**RE: McDonald's at Ventana Square
Grading and Drainage Plans
Engineer's Stamp Date: 07/07/23
Hydrology File: B10D003C3B**

Based upon the information provided in your submittal received 07/11/2023, the Grading & Drainage Plans **are not** approved for Building Permit and Grading Permit. The following comments need to be addressed for approval of the above referenced project:

C8.0 DRAINAGE PLAN

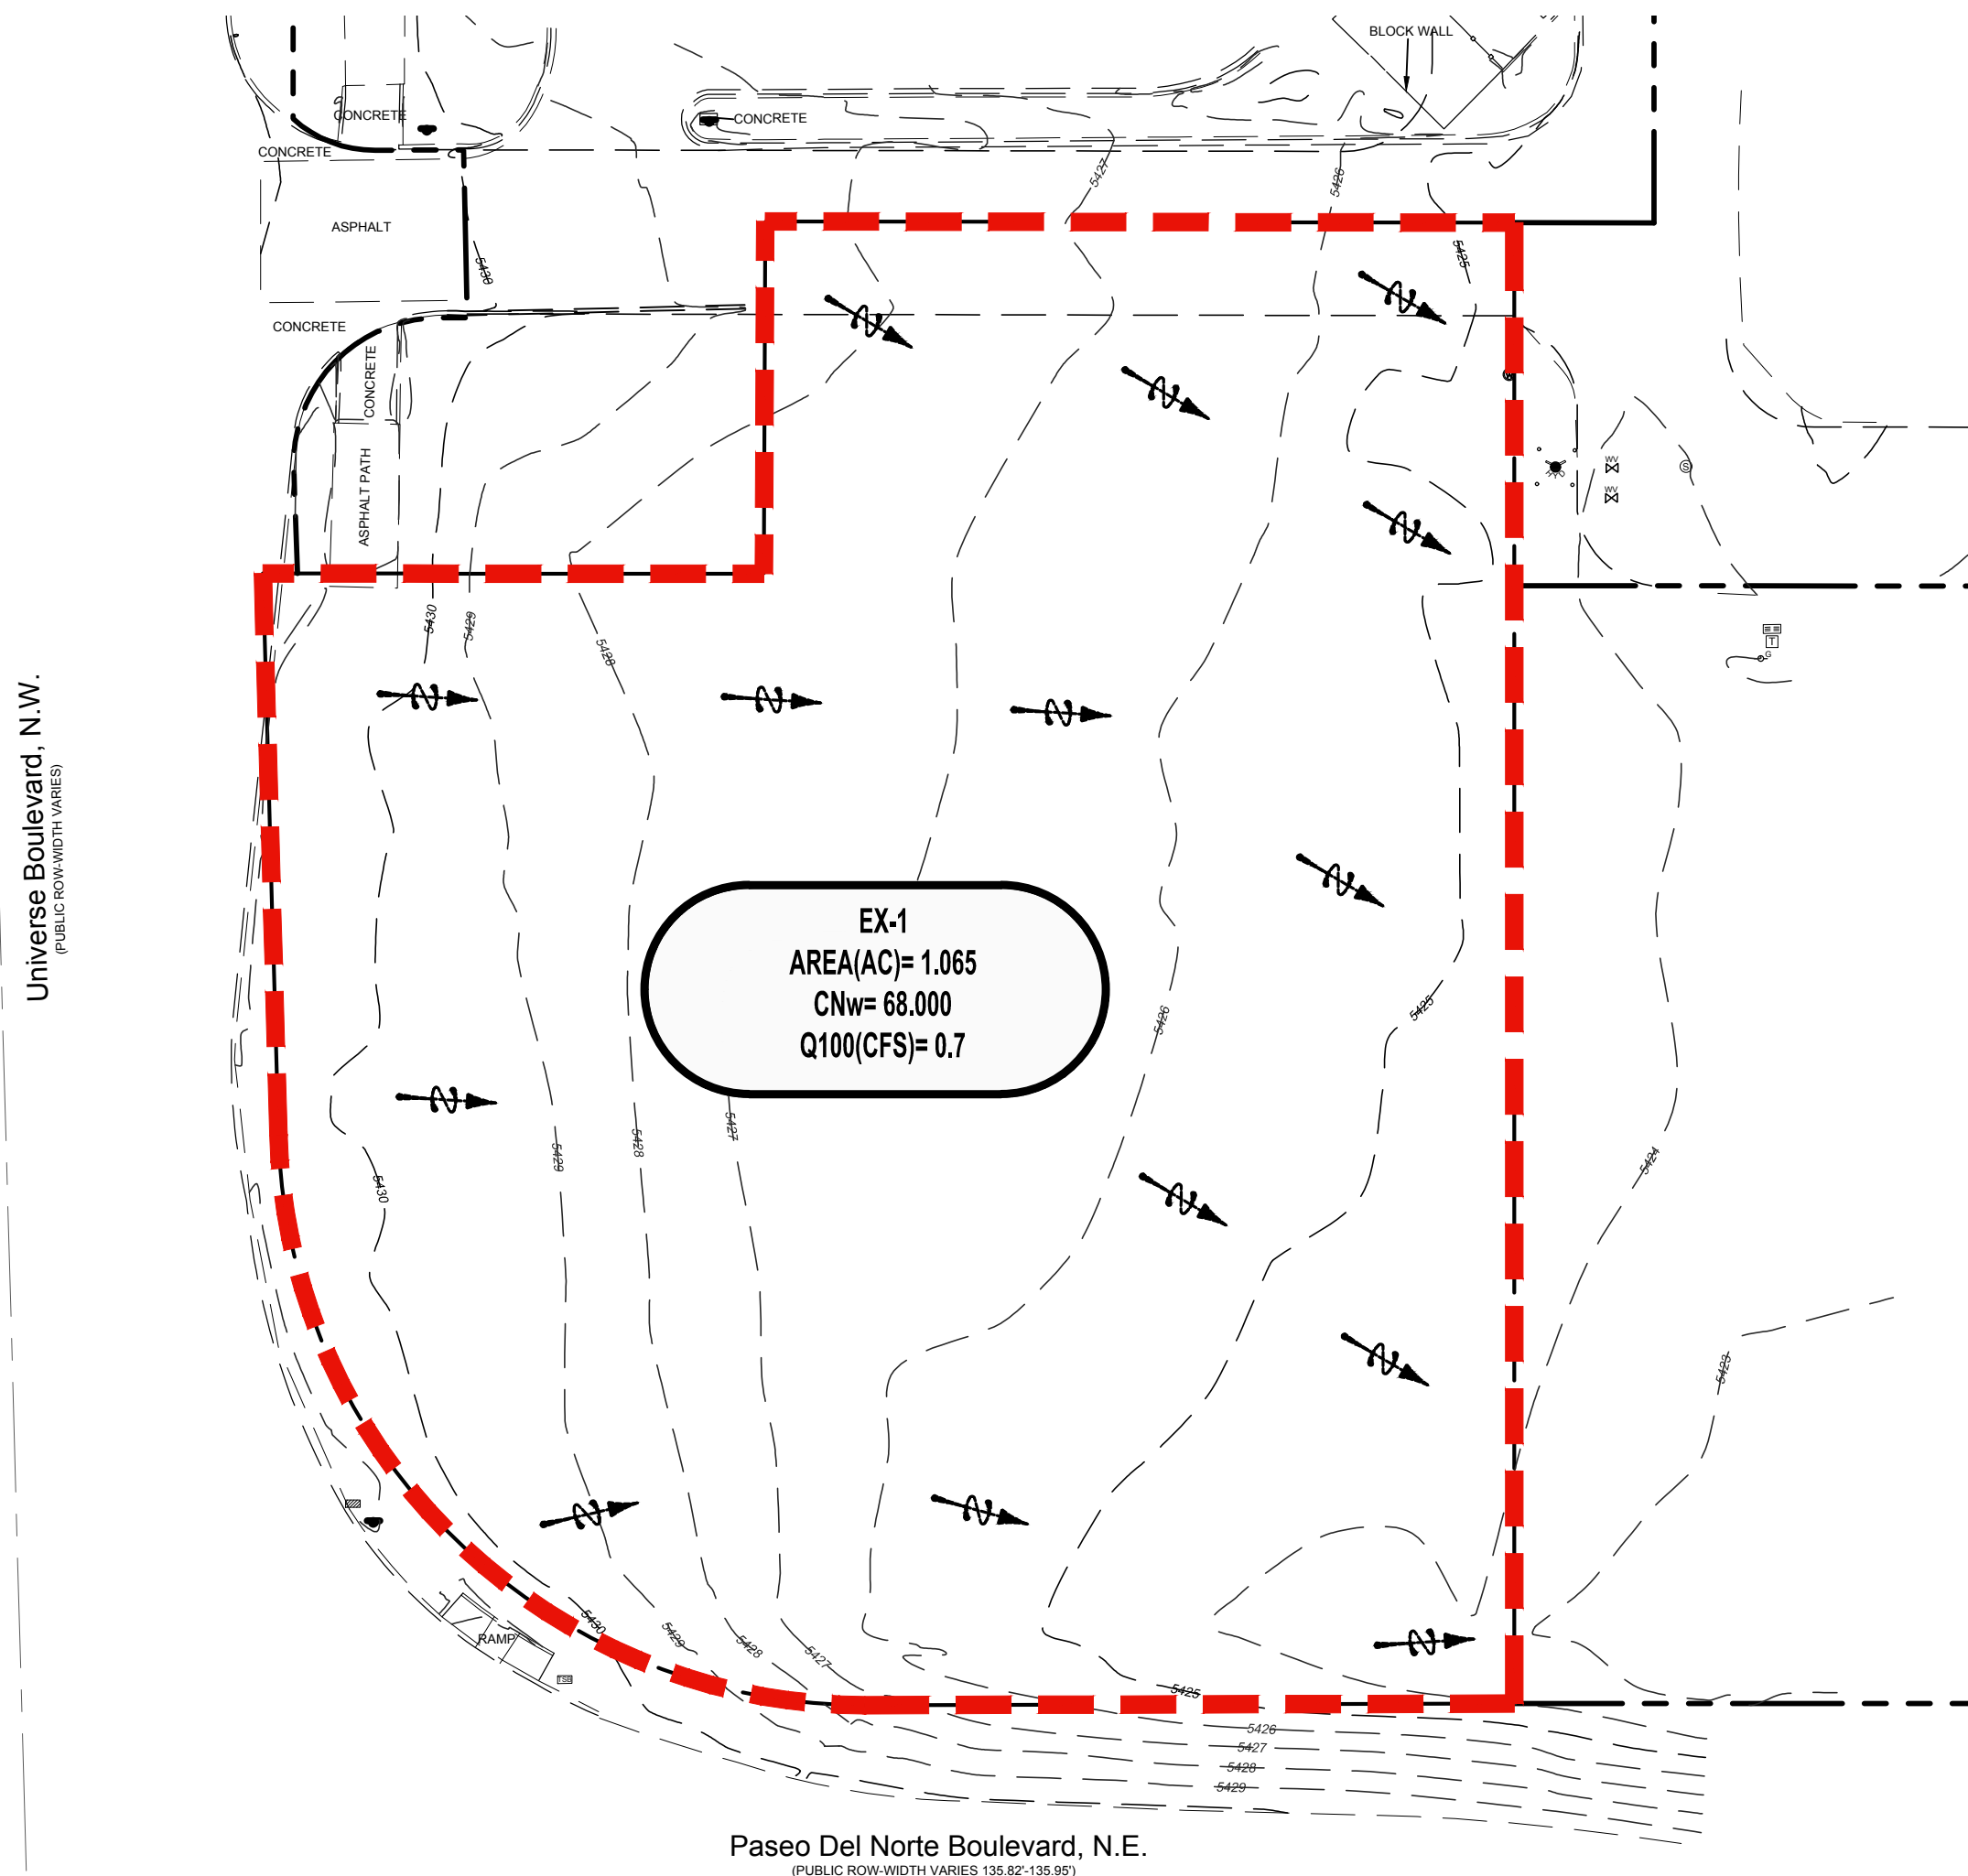
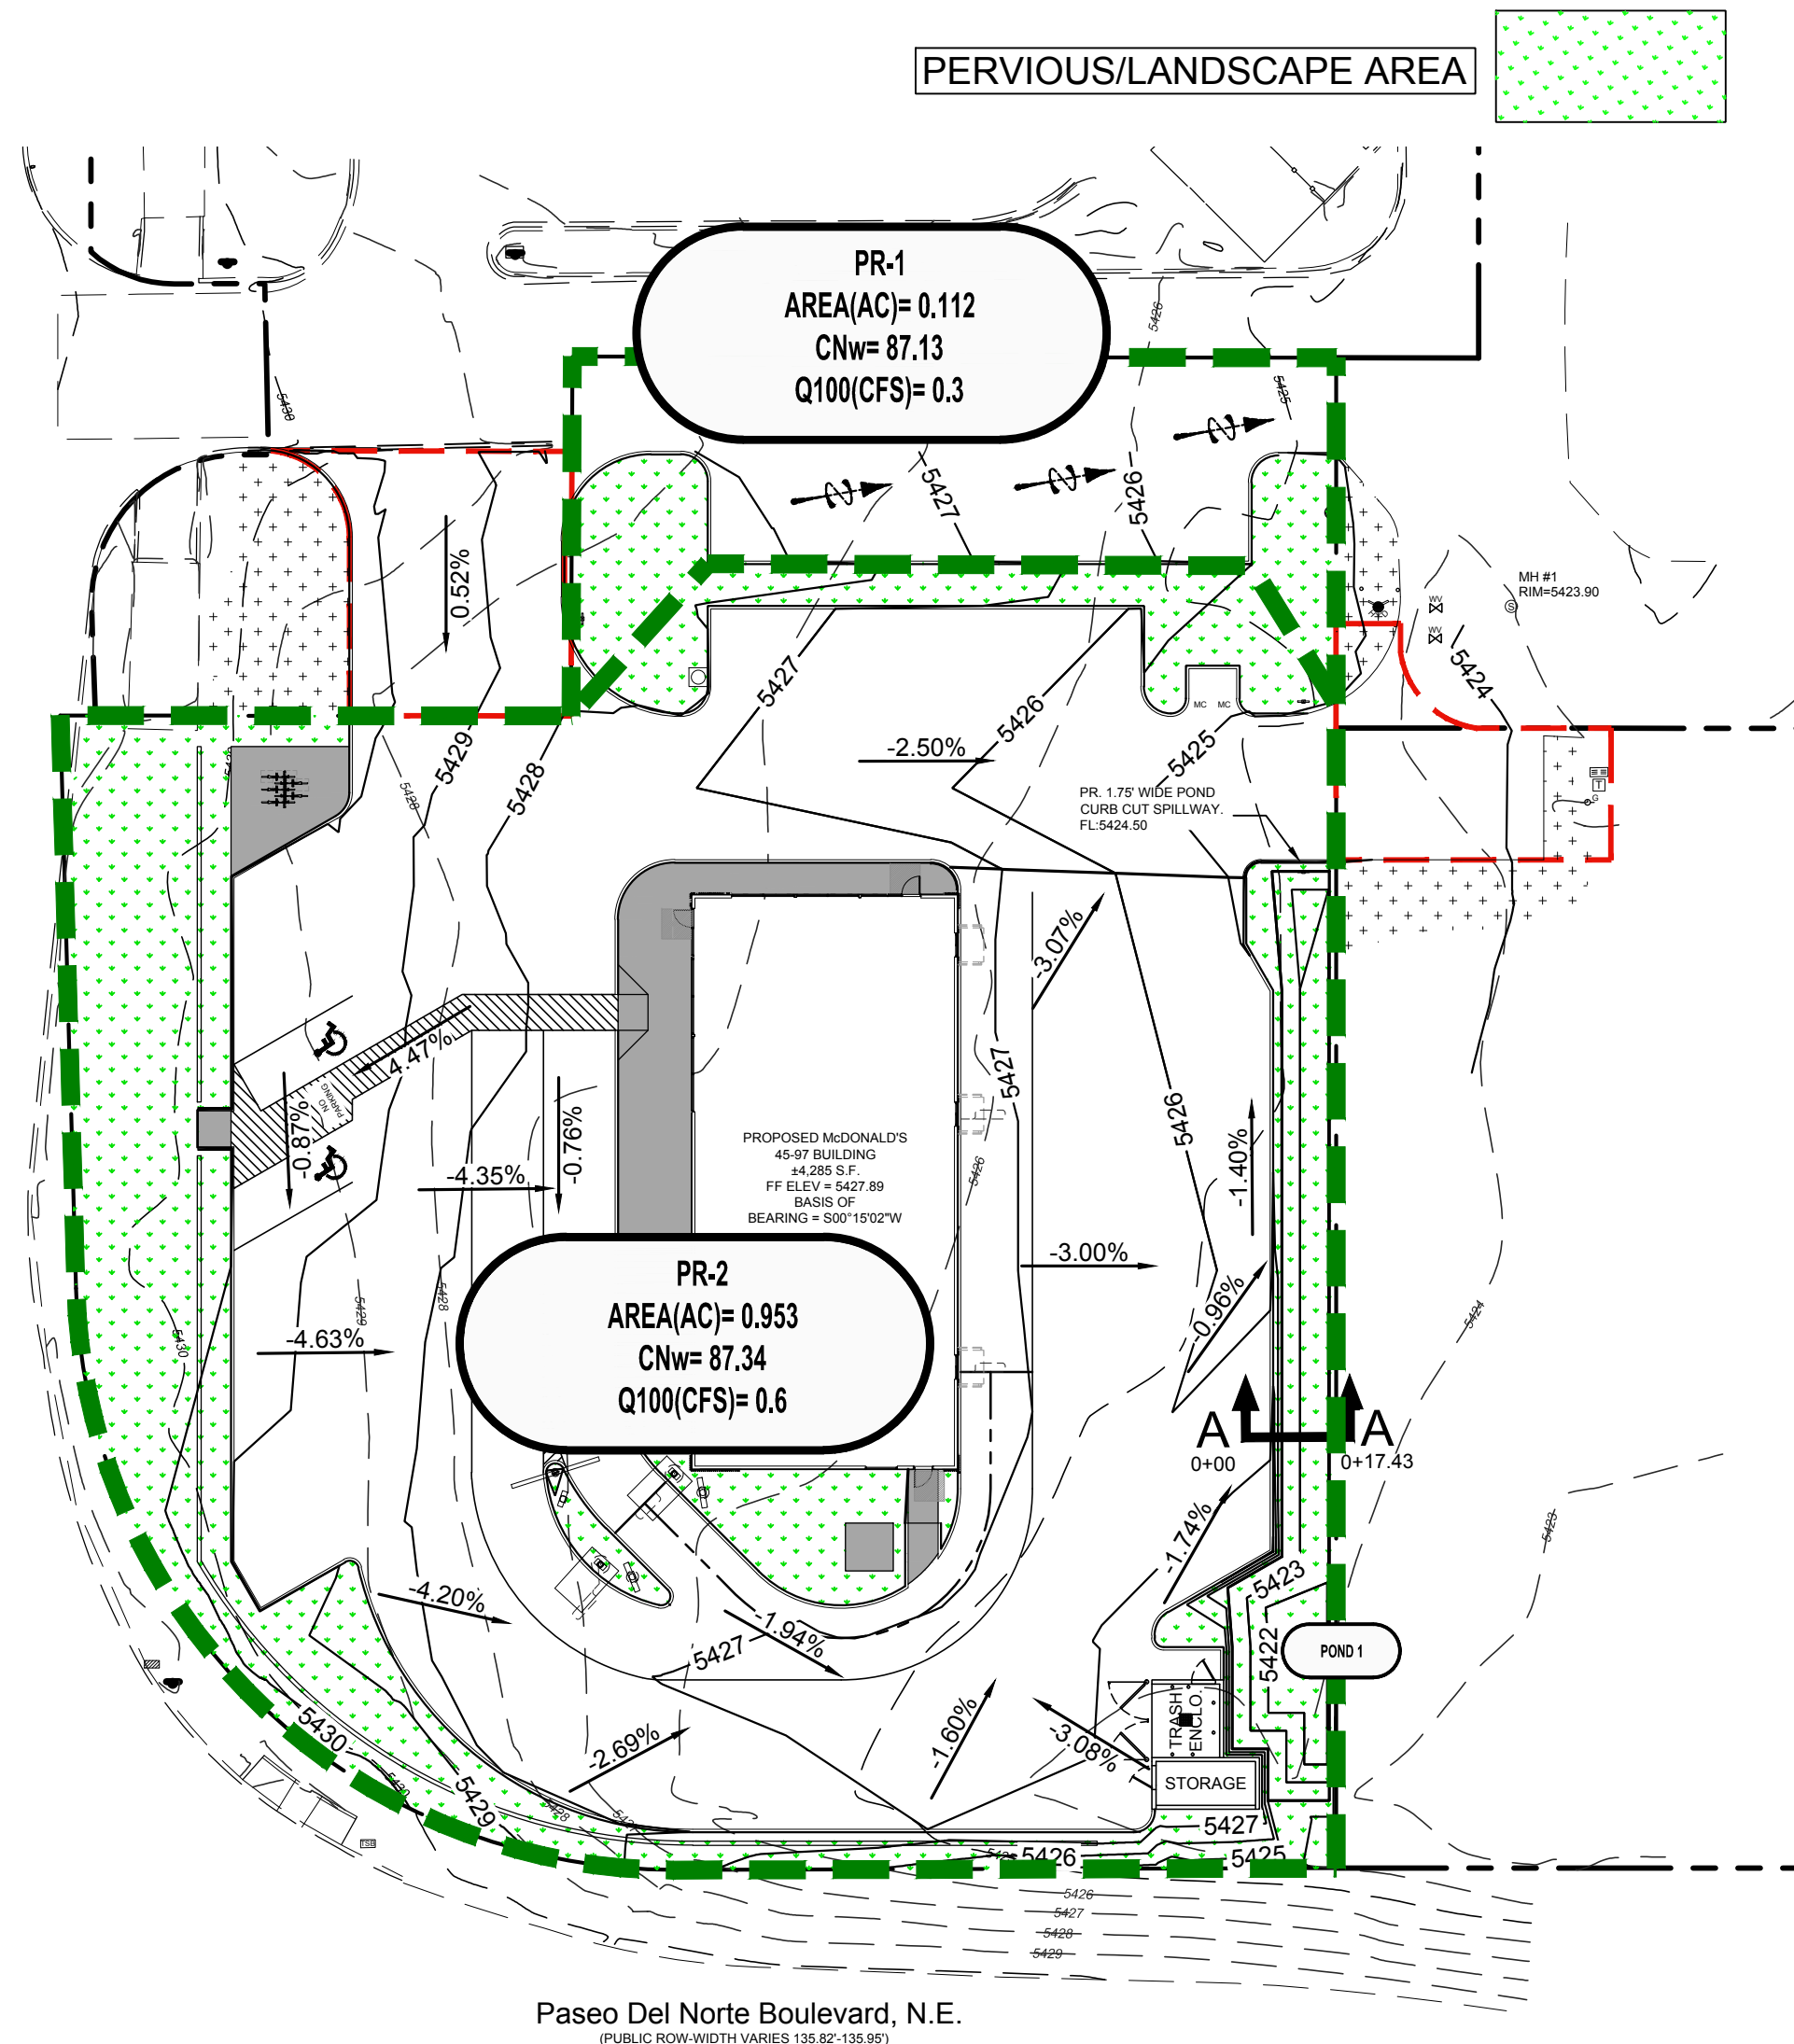
- Sheet C8.0. Please add a not in the Existing Conditions or Proposed Conditions that this site is within the Ventana Square Drainage Master Plan and that this site has an allowable discharge of 4.48 cfs. I have attached the approved Ventana Square Drainage Master Plan for your use.

- Sheet C8.0. Please use the procedure for 40 acre and smaller basins as outlined in Development Process Manual (DPM) Article 6-2(a). Please provide both the existing conditions and proposed conditions for the 100 year-6 hour storm event. The approved Ventana Square Drainage Master Plan has a great example of these calculations.
